Wavetech Harker-Victor-Roberts OGDG Returned to Draft

The attached spreadsheet addresses issues identified by staff during this Completeness Review. There is a tab for each plan and attachment required by Rule 304, a tab for the Form 2A, 2B, 2C, and Hearing Application. Tabs that are colored black are plans and attachments not required for this application. Tabs colored green are plans and attachments that are considered complete. These tabs may contain notes about COA's or follow up information being requested, but they have been found to meet the rule requirement for completeness. Tabs colored red require corrections/revisions to the plans or attachments in order to be in compliance with Rule 304. Staff have included notes and referenced relevant guidance documents and rules for these tabs.

Wavetech Harker-Victor-Roberts Helium OGDG: lands issue

Hearing Application Map:

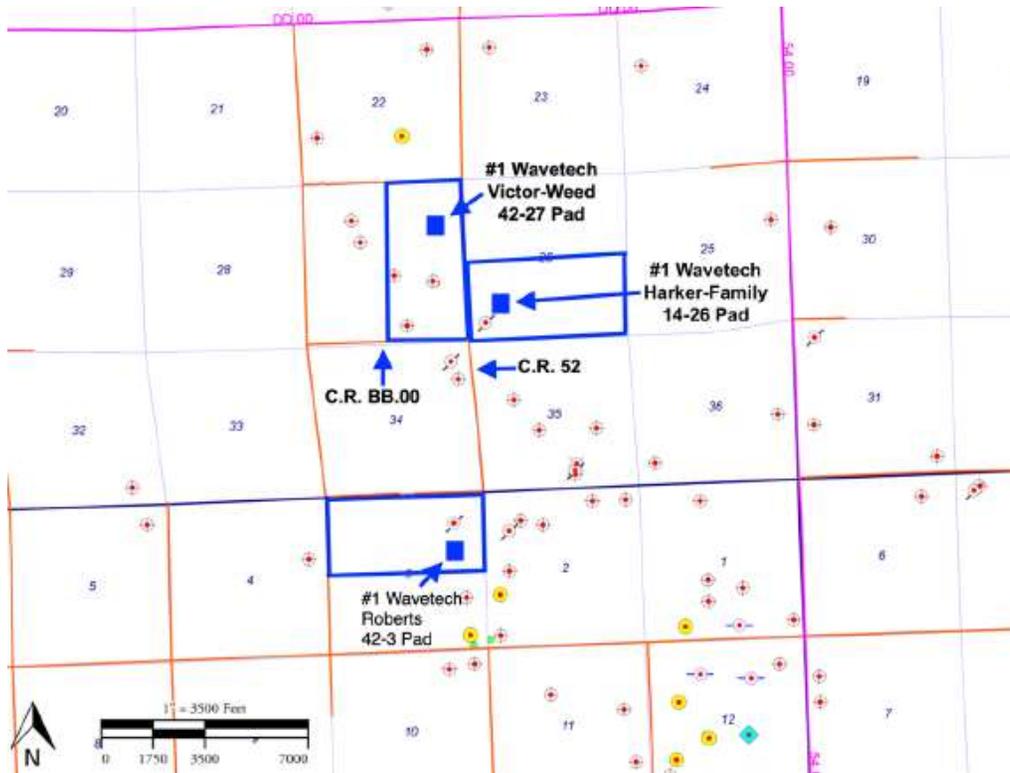
In comparing the resubmitted webforms and Hearing Application materials, there is a lingering discontinuity between the lands that I don't think I identified clearly enough with my initial review comments. Please see below:

As you can see, the webforms materials indicate that the mineral development area for the 1 Wavetech Roberts 42-3 is "E/2 Sec. 3 13S43W", but the Hearing Application states it is "N/2 Sec. 3 13S43W". Which is correct?

The mineral development area for the Roberts Location is the N/2 of Section 3. The Hearing Application is correct. Andrea, would you please update the Related Location and Flowline Map? Thank you!

Hearing Application Map:

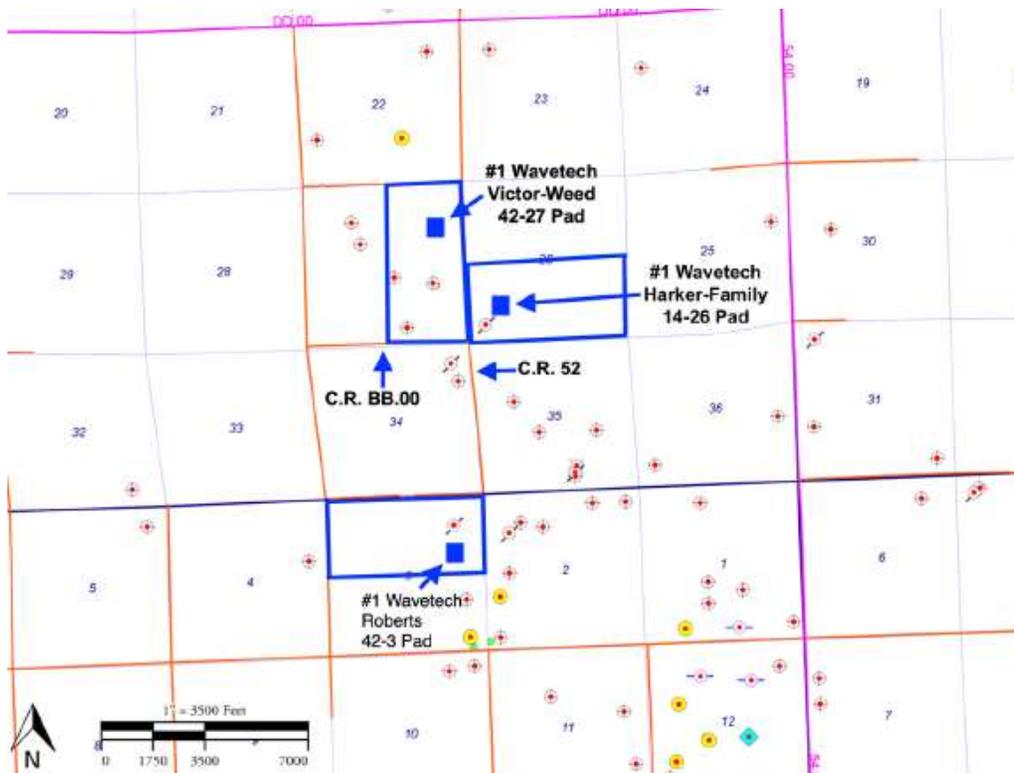
In comparing the resubmitted webforms and Hearing Application materials, there is a lingering discontinuity between the lands that I don't think I identified clearly enough with my initial review comments. Please see below:
